IEC 61000-4-11
Edition 3.0 2020-01

ELECTROMAGNETIC COMPATIBILITY (EMC) –

Part 4-11: Testing and measurement techniques
– Voltage dips, short interruptions and voltage
variations immunity tests for equipment with
input current up to 16 A per phase

CORRIGENDUM 1

Figure 2 – Short interruption

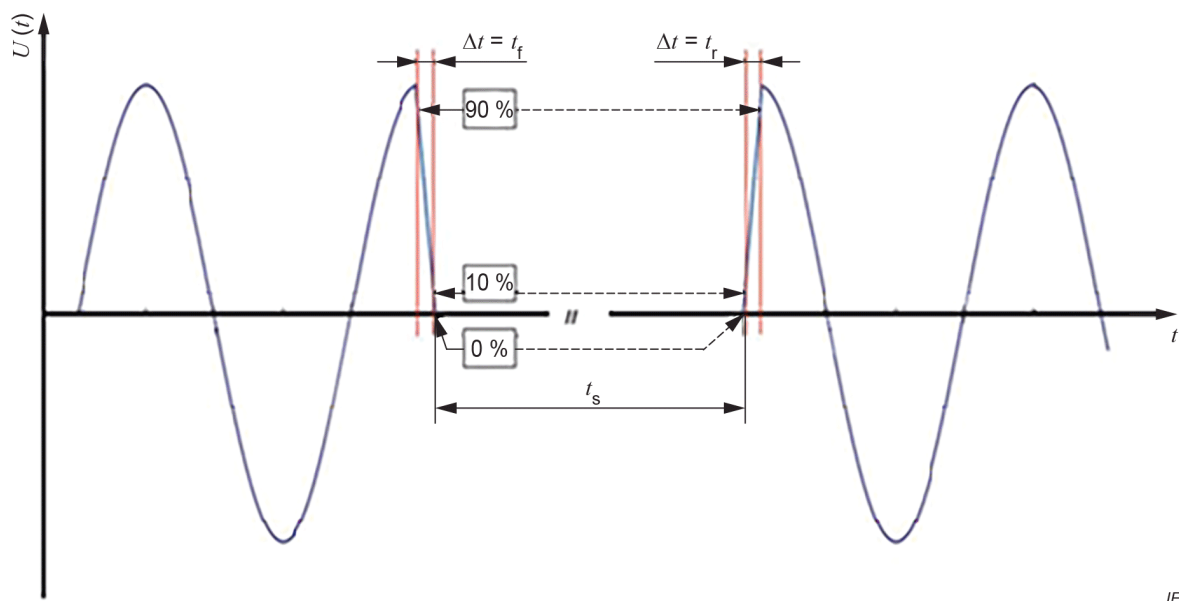
Replace Figure 2 with the following new figure:
